Rail Coach Factory, Kapurthala

Sub: Retro-fitment of 110V, 120Ah Battery in existing LVPH Coaches.

CAI NO.: ED/CAI/043 dated: 02.06.2025

**COACH ALTERATION INSTRUCTION
FOR RETRO-FITMENT OF 120AH, 110VDC VRLA
BATTERY BANK IN PLACE OF
EXISTING 70AH, 110VDC VRLA BATTERY BANK
IN LVPH COACHES**

DRG.NO. VP70019

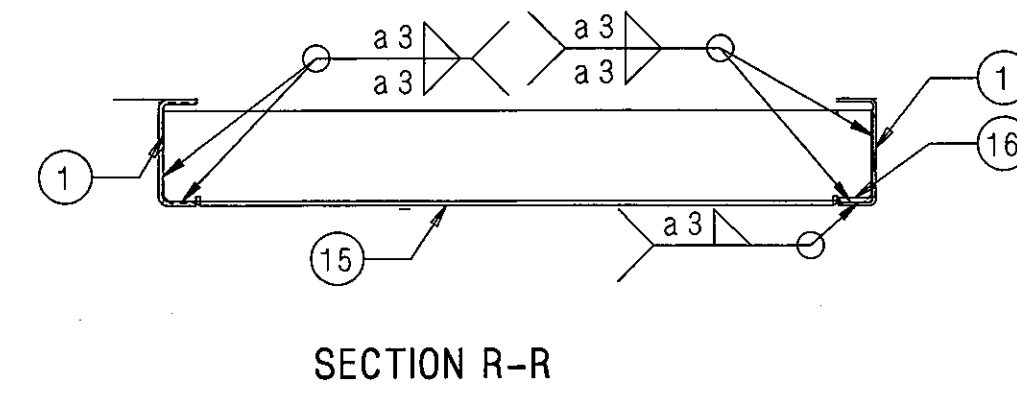
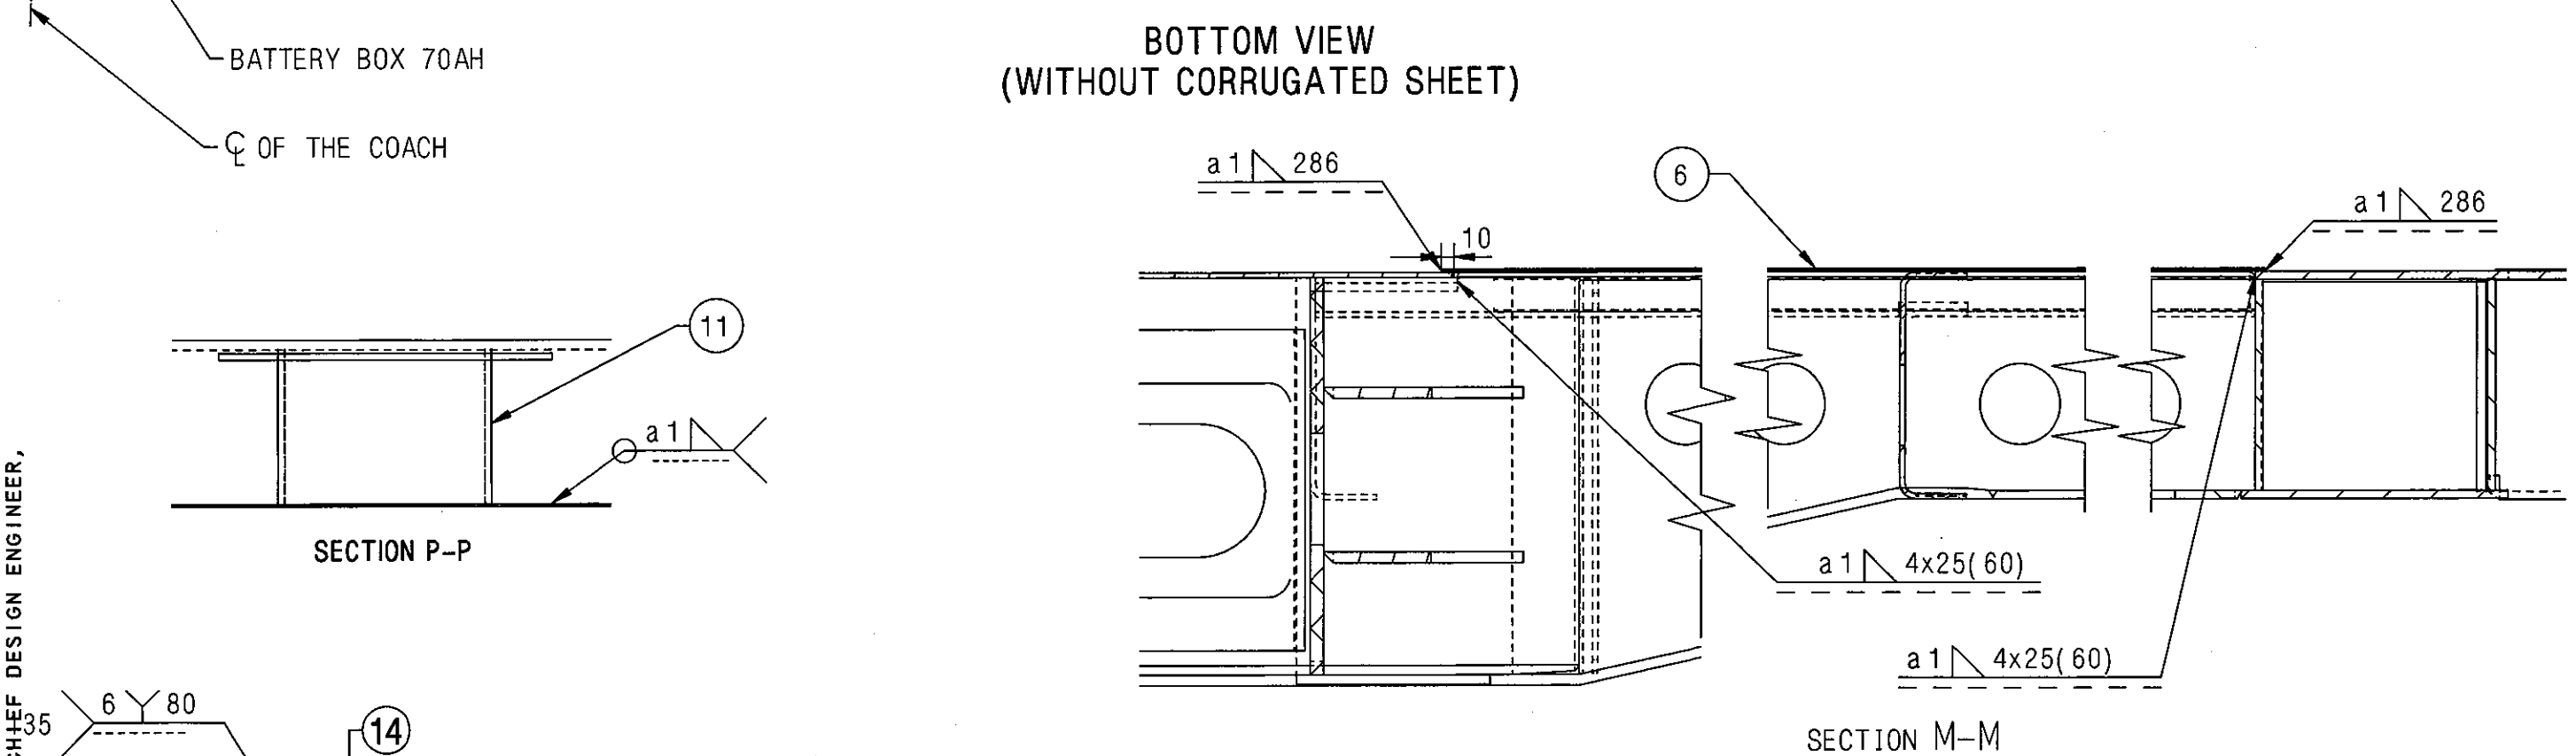
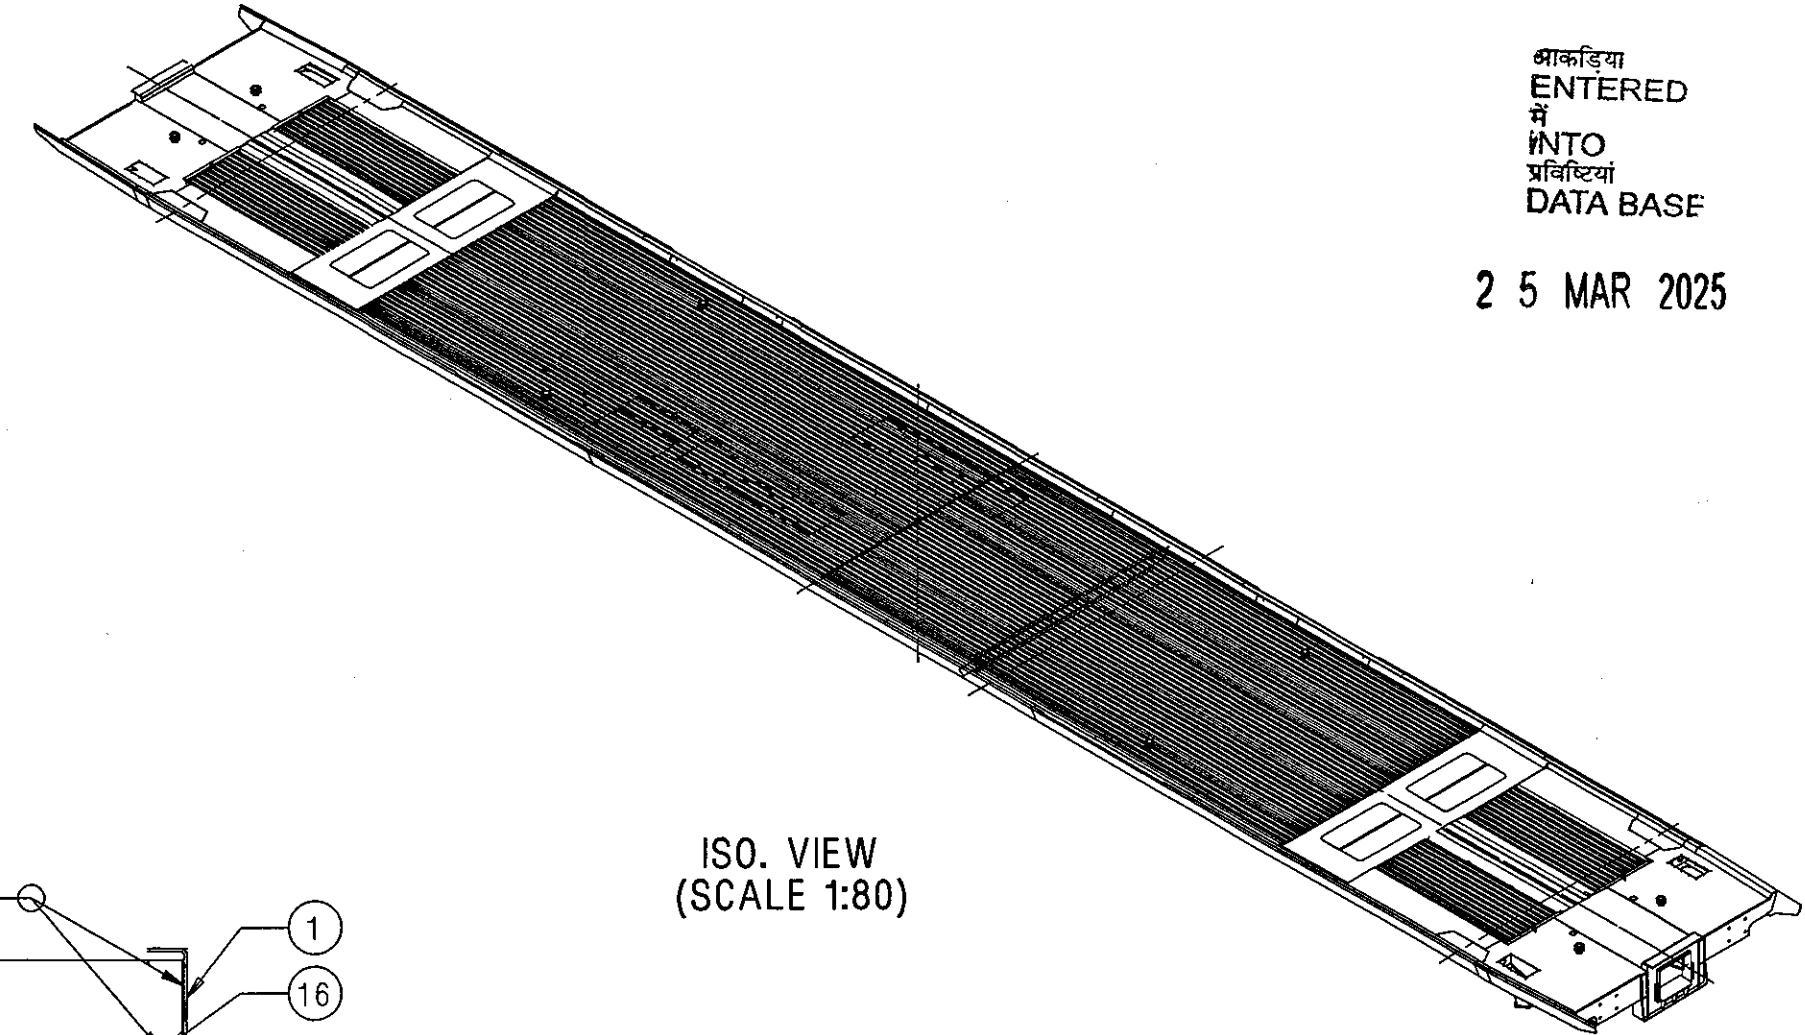
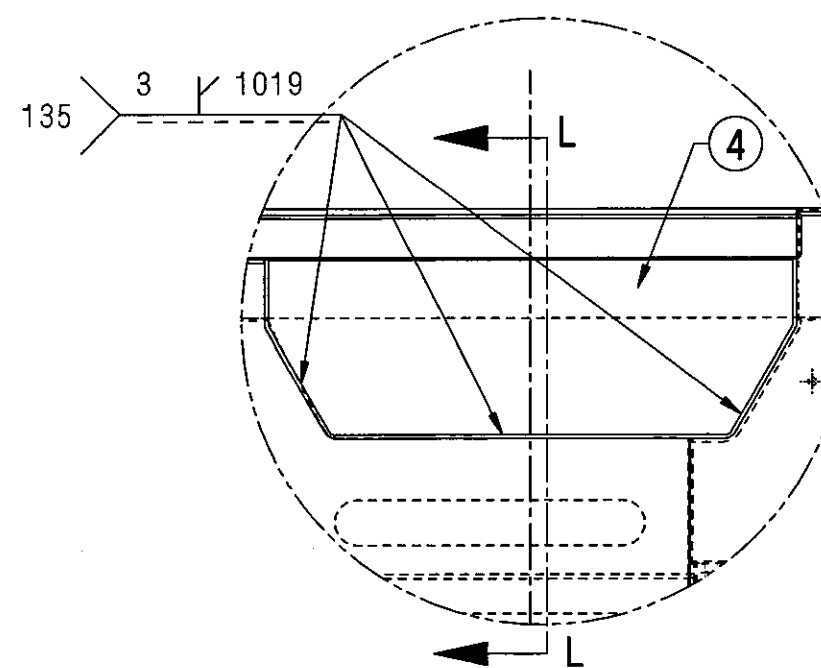
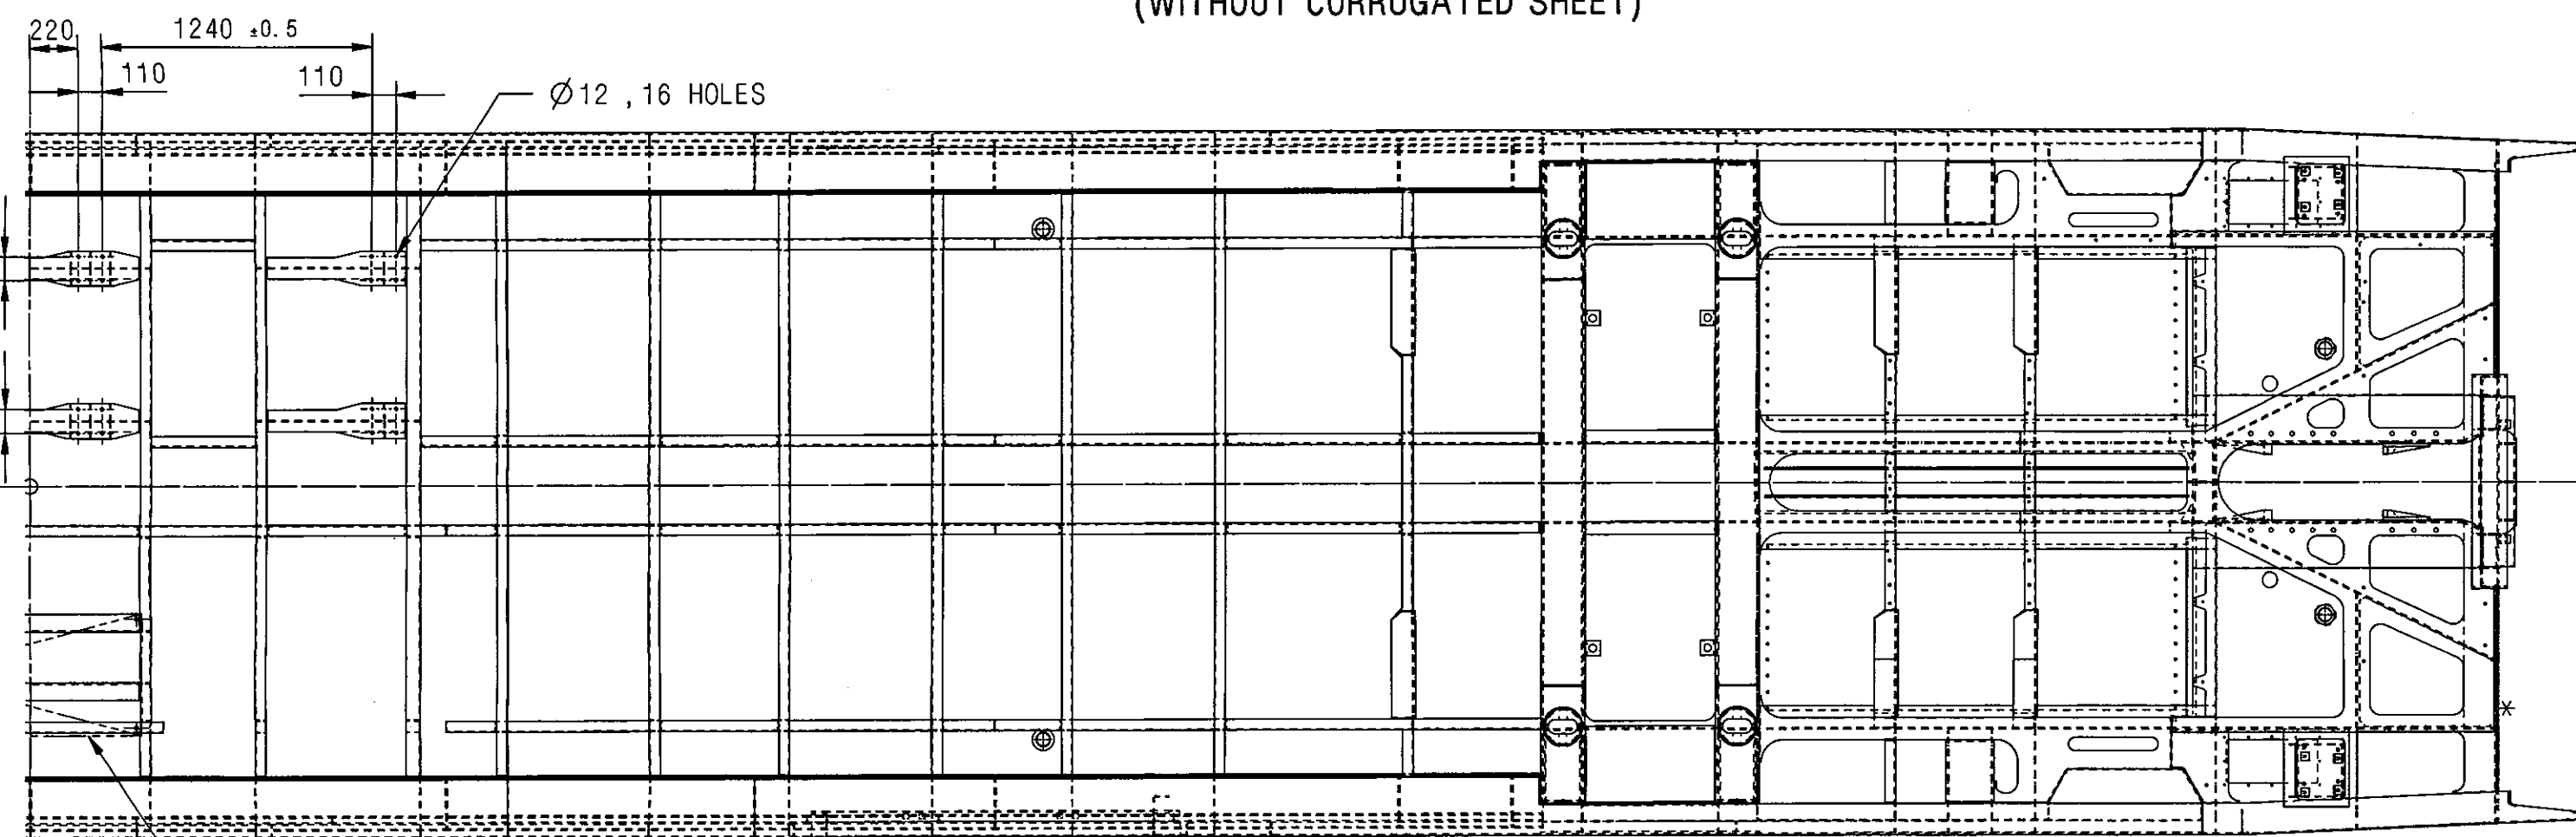
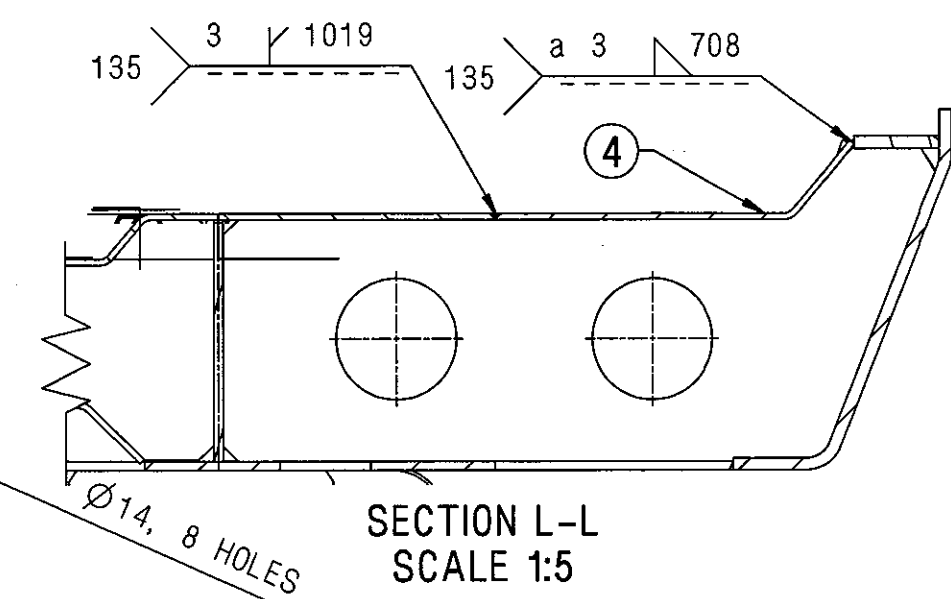
- Removal of +VE & -VE fuse from respective Battery Fuse Boxes.
- Disconnection of mains +VE & -VE cables (10 sqmm) from battery monoblocks. (Ref. Harness Route no. 35 & 39, RCF Drg. No. VP70019, alt 'b')

- C. Loading of fully charged 120AH, 110VDC VRLA battery set alongwith tray arrangement.
- D. Interconnection cell connections & provision of Battery terminal caps (As per Recommendations of Battery OEM).
- E. Connection work of battery bank (refer RCF Drg. No. VP70019, alt 'b'). Precaution shall be taken to avoid any short circuit of +VE & -VE battery terminals.
- F. Re-insertion of battery fuse inside Battery fuse boxes.
